TO: Mayor J. Clark Boddie, City of Palmetto
ATTN TO: Cindy Hanson, City Clerk, City of Palmetto
FROM: Mike Alexander, Director, ARC Center for Livable Communities
RE: Development of Regional Impact (DRI) Review

Name of Proposal: Palmetto Business Center DRI 3684

Description: A DRI review of a proposal to construct 1,109,160 SF of industrial warehouse space in two buildings with associated truck and car parking areas on a 128 acre site off of Tatum Road in the City of Palmetto in Fulton County.

DRI SITE PLAN

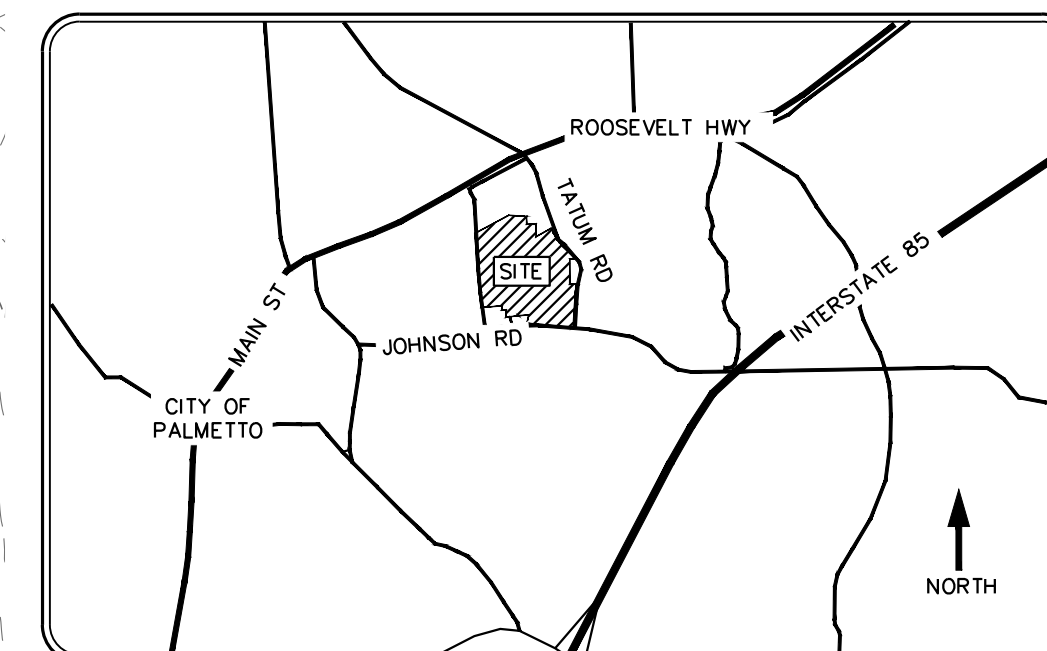
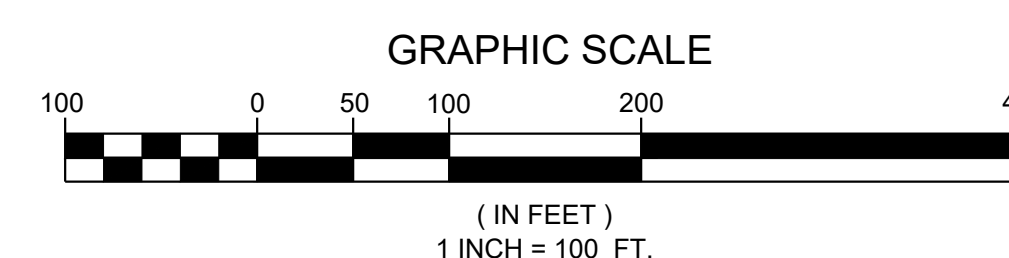
Project elements intrude into stream buffer areas at several locations; these intrusions may require a City variance.

Incorporation of green stormwater and heat island mitigation designs for the roughly 1,037 surface car and truck parking spaces proposed would be supportive of regional environmental policies.

A total of 786 car parking spaces and 251 truck parking spaces are provided; no EV charging stations appear to be proposed. The provision of some EV parking spaces would be supportive of regional transportation/EV infrastructure policies.

Stream Buffer Ordinance as well as the 25-foot State Erosion and Sedimentation Act buffer are shown on both streams. No intrusions are shown on the western stream, but the central stream is affected by two stream crossings and portions of the parking and truck courts for the building identified as Building 200 intrude into the buffers. While transportation stream crossings are allowed under the City ordinance, the parking and truck court intrusions, as well as any other intrusions, may require a variance from the City.
